## **R22 SERVICE BULLETIN SB-120B**

**SUBJECT:** Tail Rotor Blade Inspection and Replacement

**EFFECTIVITY:** P/N A029-2 tail rotor blade S/Ns 11279 and prior (A029-2 REV U and prior). Affected blades were factory-installed on R22 Helicopter S/Ns 4873 and prior.

SPECIAL TAIL ROTOR TIP PREFLIGHT INSPECTION

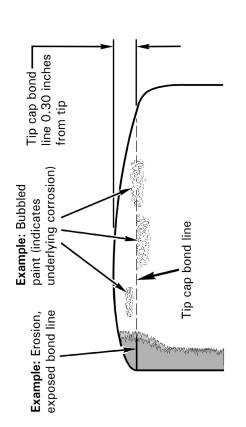
of tail rotor tip area.

If bubbled paint or other evidence of

Conduct visual inspection

corrosion is observed at or adjacent to tip cap bond line or if any portion of tip cap bond line is exposed, do not fly helicopter. Comply with latest revision of R22 SL-93 prior to
